**Assessment Report on
Feasibility of Tree Support Systems proposed in
Study on Stonewall Trees on Slope no. 11SW-A/R577
Bonham Road, Hong Kong**

Sketch 2.1

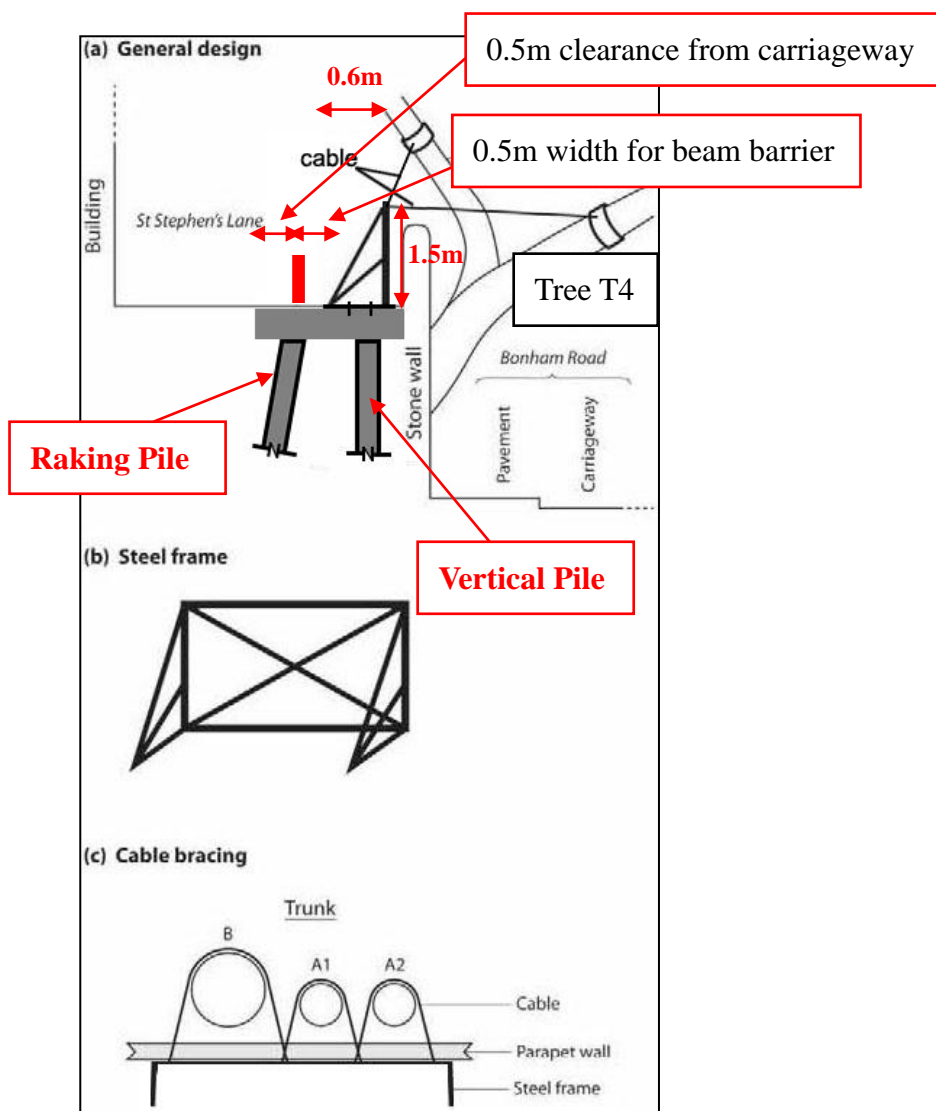
2.3.1 Method A is considered infeasible for the following reasons:

- (i) There are no statutory powers for government authorities including HyD to anchor the cable system on private structure/building. The general view of nearby building is shown on Photo 2.1. As the building facade does not belong to individual owner, consents from owners' incorporation or all building owners are required. However, there is no incentive for the building owners to agree the installation of cables on their building. Furthermore, as extra loading due to cable anchorage will be applied on the building, the liability and maintenance issues are difficult to be resolved. The works will also affect and limit future maintenance of building facade and redevelopment of the building.

- (ii) Even if agreement can be obtained from the owners, the anchorage of the proposed cable bracing system will have to be provided at the facade of the common podium of the nearby Golden Phoenix Building to avoid potential structural and visual impact to individual residential units. With this cable supporting system, large tension force (in the order of 30 tonnes for T4 and 4 tonnes for T5) will then be induced in the cables to support or stabilise the tree due to the dead weight of the tree and wind loads acting on the tree. There can be detrimental damage to the adjacent buildings and severe injury to the public caused by the immense destructive force from the failure of trees/branches/cables and associated parts during typhoon or strong gust/monsoon wind. It is estimated that two anchorage plates of 550mm x 550 mm size with four 24mm diameter high tensile strength bolts anchoring 210mm in the building are required (with at least 270mm thick concrete being required to hold the bolts). However, as the building is quite old, the condition of concrete is uncertain. Moreover, the estimated wall thickness is only 250mm (Photo 2.3). Therefore the suitability of the anchorage is in doubt. The anchorage depth of 210mm

would also affect the existing reinforcements inside structural members of the building.

- (iii) As a minimum headroom¹ of 5.1m has to be maintained at St. Stephen's Lane for vehicular traffic, the cables should be mounted at a high position of the tree where the tree branches may not be strong enough to take the high tension forces. (Photo 2.2)
- (iv) The structural stability of the building will be affected due to the extra loading from the cable system which has not been allowed for in the original design of the building. The stability of the building is required to be reassessed and strengthening works on the building will probably be required. Submission to Buildings Department for their approval is also required for the proposed works and it will take considerable time for the required processes while the public is being exposed to the risk of tree failure.

Photo 2.4 – St. Stephen Lane

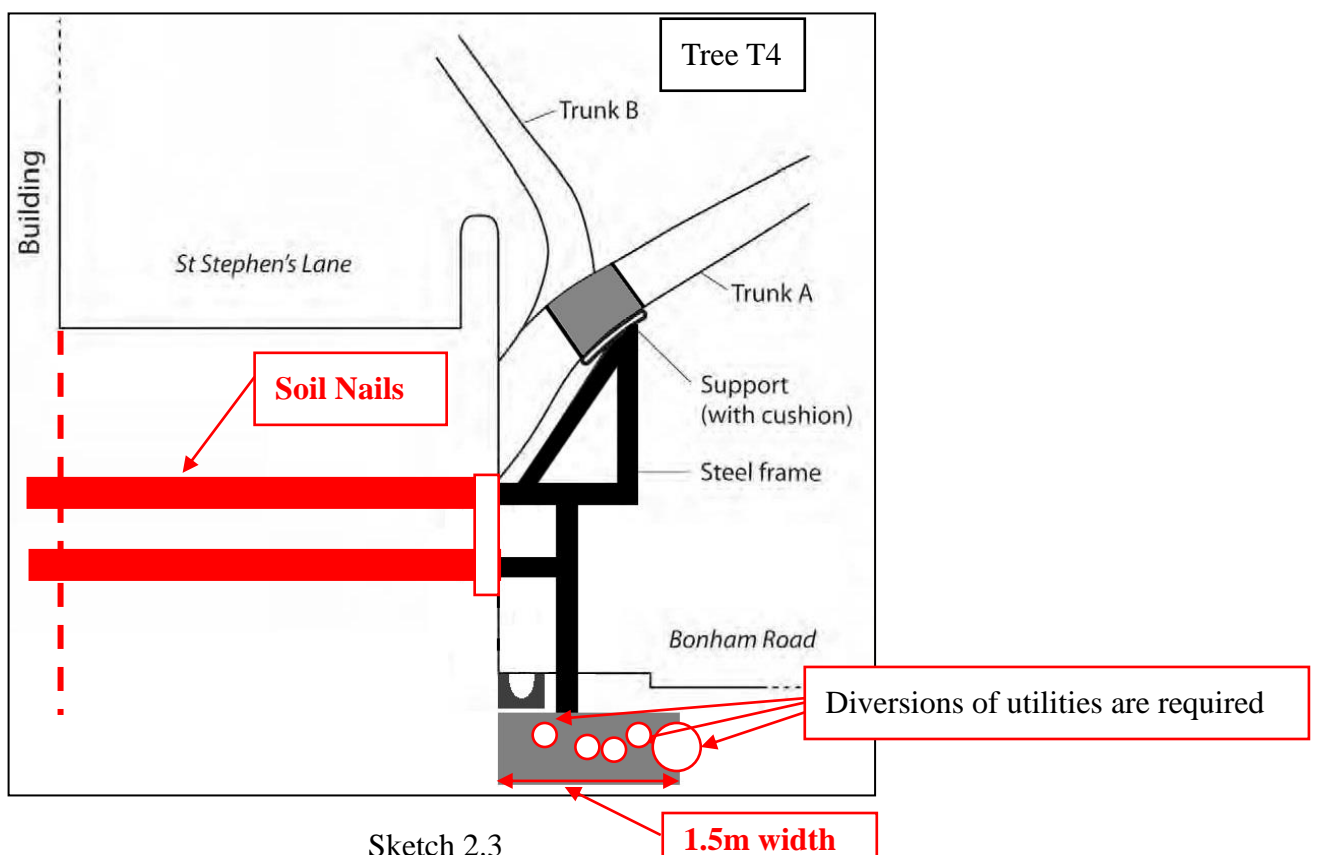
- (i) St. Stephen's Lane is a one-lane two-way carriageway of about 4.5m width, being shared use with pedestrians. The existing road width is not up to current standard due to site constraints. The road width at the location of Tree T4 and T5 are 4.25m and 4.50m respectively. As the absolute minimum carriageway width requirement for a single track access road serving as emergency access² is 3.5m and the horizontal clearance requirements for carriageway to building/structure/obstruction³ is 0.5m on each side, the existing road width is already below or at the minimum standard. It is not viable to install any structures at St. Stephen's Lane due to the road width constraint. (Photo 2.4)

- (ii) The estimated size of the supporting frame would be 0.6m in width perpendicular to the parapet wall. With 0.5m width allowed for erecting a beam barrier to protect the frame and 0.5m clearance from the barrier to edge of carriageway, the structure will occupy 1.6m road width at least. Even the widest section of St. Stephen Lane (about 5m) cannot provide the required road space for the proposed structure because a minimum clear road width of 3.5m as mentioned in (i) above is required.

Photo 2.5 – Southern footpath at Bonham Road (viewing from the east)

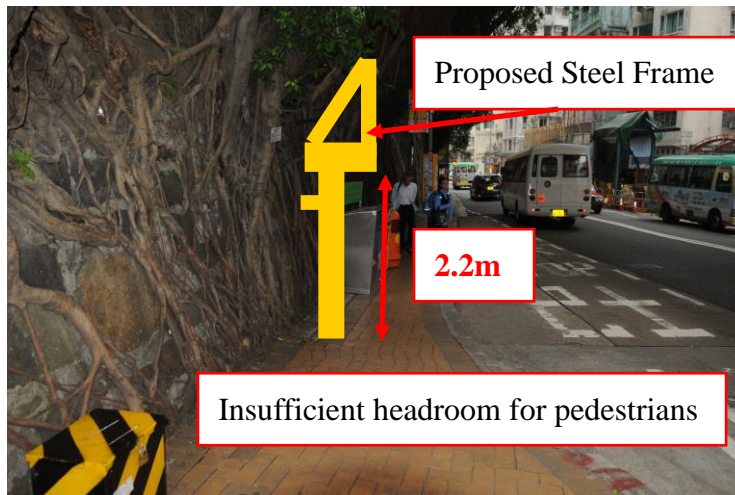
- (i) From our survey, the lower part of the tree is only 2.5m above the existing footpath at Bonham Road. The estimated size of the supporting beams is 0.3m in depth. As such, minimum headroom of 2.3m for footpath cannot be maintained if the supporting frame is to be constructed on the masonry wall adjacent to the footpath. (Photo 2.5)

Sketch 2.4

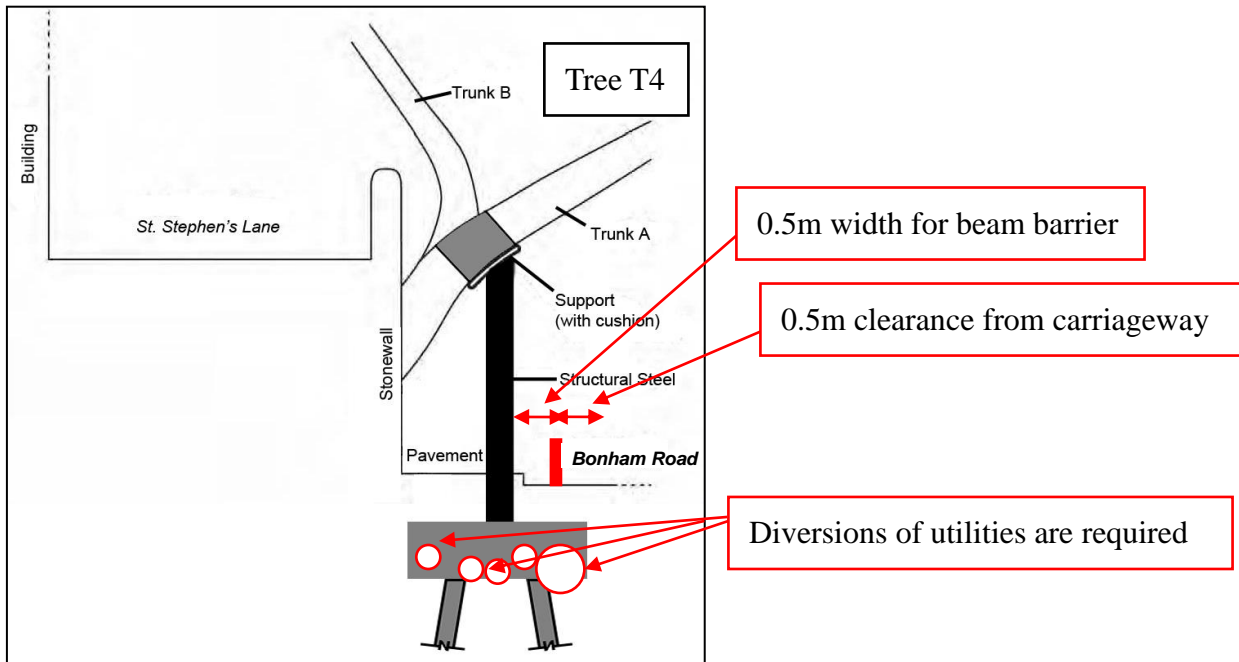
2.6.1 Method D is considered infeasible for the following reasons:

- (i) The estimated size of the anchor plate is 0.4m in width. With 0.5m width allowed for beam barrier to protect the plate and cable and 0.5m clearance from the barrier to edge of carriage way, the structure will occupy 1.4m road width at least. However, as mentioned above, there is insufficient road space at St. Stephen Lane to provide the required road width.

- (ii) Moreover, any transfer of extra loading to the crest of the stonewall will create extra overturning moment and lateral force on the stonewall. Additional stonewall strengthening works will be required. (See also Method B, para. 2.4.1(iii).)

- (iii) Owing to low anchorage point, the overturning moment of the dead load and wind load of the stonewall tree will create a very large tension force on the cables (in the order of 260 tonnes for T4 and 42 tonnes for T5). The foundation of the structure would be in the form of eighteen mini-piles (twelve raking and six vertical piles) at St. Stephen's Lane to

provide the required lateral resistance. The raking piles would hit the foundation of the nearby building and make the scheme infeasible. (See also Method B, para. 2.4.1(iv).)

- (iv) In addition, diversion for underground electric cables at St. Stephen Lane is required. (See also Method B, para. 2.4.1(v).)

Photo 2.6 – Southern footpath at Bonham Road (viewing from the west)

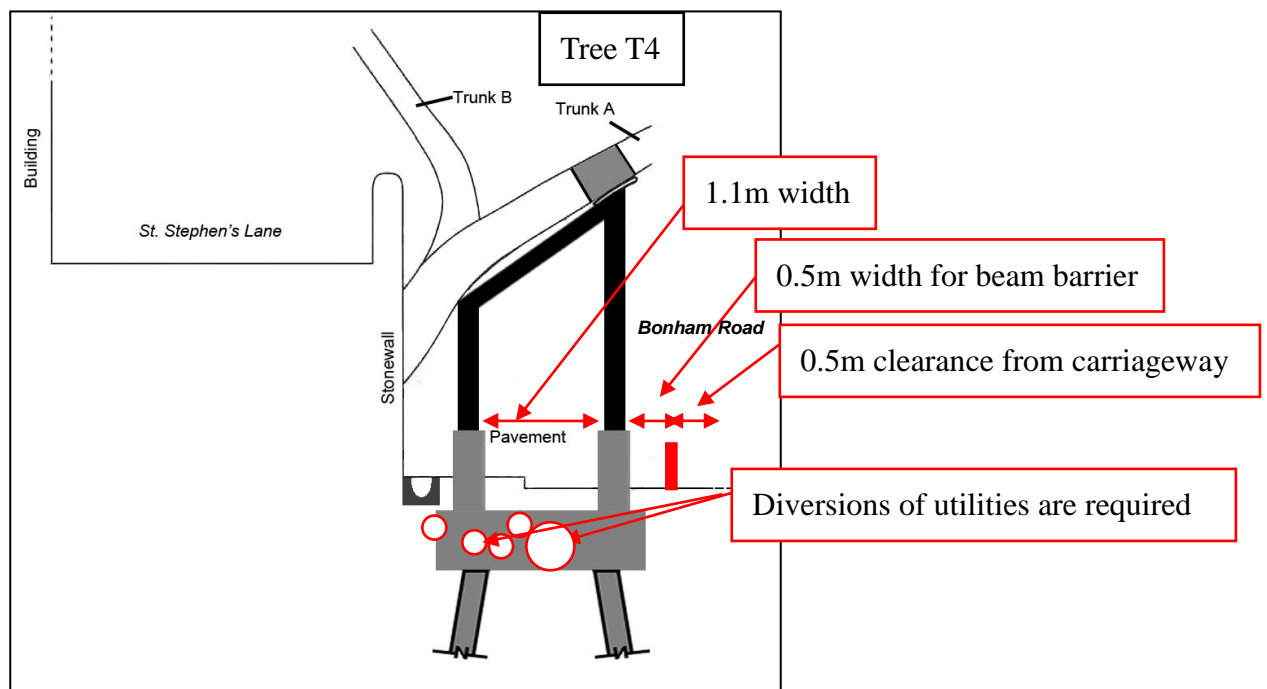
- (i) The existing footpath width near tree T4 and T5 is only 1.23m (Photo 2.6) which is not up to current standard. It is already too narrow to accommodate both pedestrians and passengers waiting at the bus stop. The construction of structures occupying extra footpath spaces is therefore impractical.

Sketch 2.6

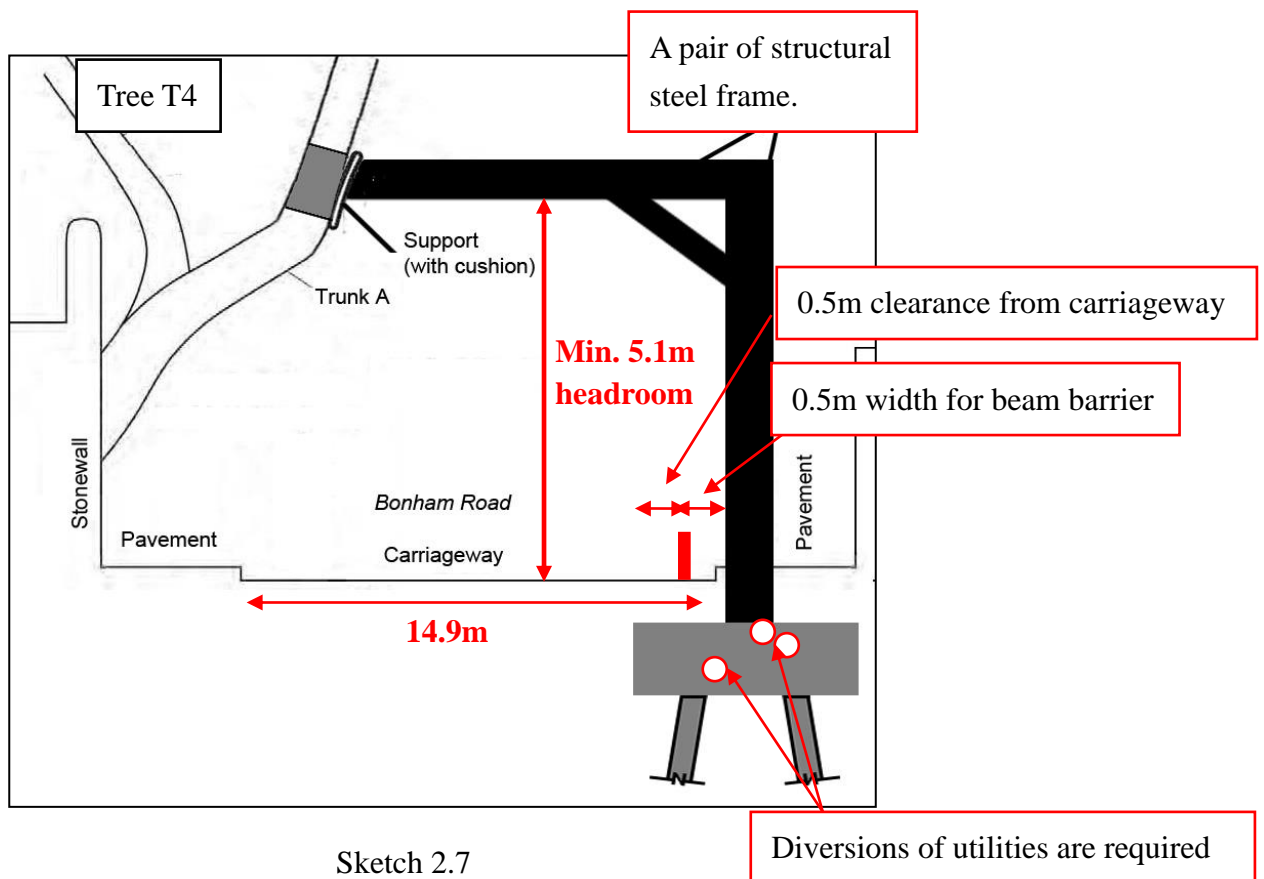
2.8.1 This method is considered infeasible for the following reasons:

- (i) The existing footpath width near tree T4 and T5 is only 1.23m. (See also Method E, para. 2.7.1(i).)
- (ii) If the bus stop could be relocated, an additional road width of about 2.4m might be available. With the provision of beam barrier and 0.5m clearance from the carriageway, the remaining road width for pedestrians is only 1.1m (Sketch 2.6) at most which is undesirable. Most importantly, the relocation of the bus stop is impractical. (See also Method C, para. 2.5.1(iv).)
- (iii) Diversions of utilities at the southern footpath of Bonham Road are required. (See also Method C, para. 2.5.1(iii).)
